OPTIONAL SERVICE BULLETIN

OSB 40NG-040/1

Type: DA 40 NG

Installation of the nose landing gear fairings for the lowered nose landing gear (MÄM 40-791/OSB 40NG-039).

DETAIL A

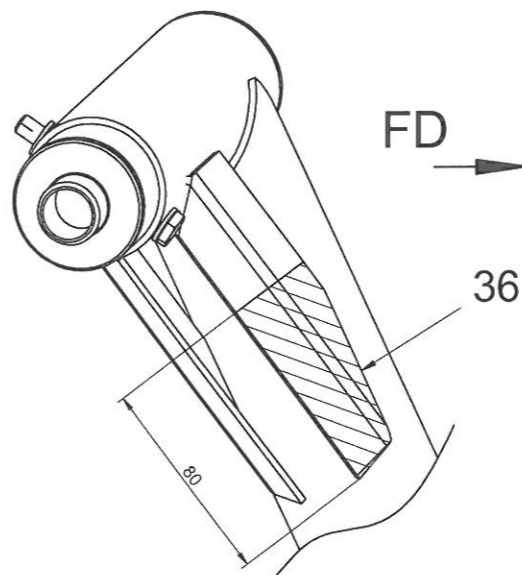
REVISION				
REV	SH	ZONE	DESCRIPTION	DATE
D	02	ALL	OÄM 40-345/b NEW NLG SPEEDKIT DUE TO CHANGED NLG LEG GEOMETRY.	03.03.2015
E	02	ALL	REDLINECORRECTION FLAG NOTE 2.5 AND 2.6 NEW ADDED. IN DETAIL A ITEM NUMBERS 31,21,17 FLAG NOTES 2.5, 2.6 DIMENSIONS 10 ±2mm AND 15 ±5mm NEW ADDED.	27.05.2015
F	02	ALL	OÄM 40-345/c FLAG NOTE 2.1 CORRECTED. FLAG NOTE 2.5 CANCELLED. FLAG NOTES SORTED NEW. IN DETAIL A DIMENSION 15 ±5mm CANCELLED. DIMENSION 10 ±2mm CORRECTED TO 15 ±2mm. ITEM NUMBERS 29,20, 24 CORRECTED TO 31,21,25. BY ITEM NUMBERS 30,21 16x CORRECTED TO 12x. ITEM 34 CORRECTED. ITEM 36 NEW ADDED.	28.05.2015

- 2.1 WRAP EPDM-FOAM TWO TIMES ALONG NOSE GEAR LEG PER LOCATION. END OF FOAM SHOULD LOOK DOWN THAT WHEN THE FAIRING IS INSTALLED THE FOAM IS PUSHED DOWN.
- 2.2 BOND ITEM 35 CENTRIC ONTO ITEM 18 USING INTERIOR GLUE.
- 2.3 ONLY FOR USE WITH MÄM 40-631.
- 2.4 FOR FURTHER INFORMATION TO INSTALLATION OF ADDED ITEMS REFER TO P/N D44-3200-00-00X03 (USE LAST REVISION LEVEL).
- 2.5 ONLY FOR OÄM 40-345 WITH MÄM 40-791.
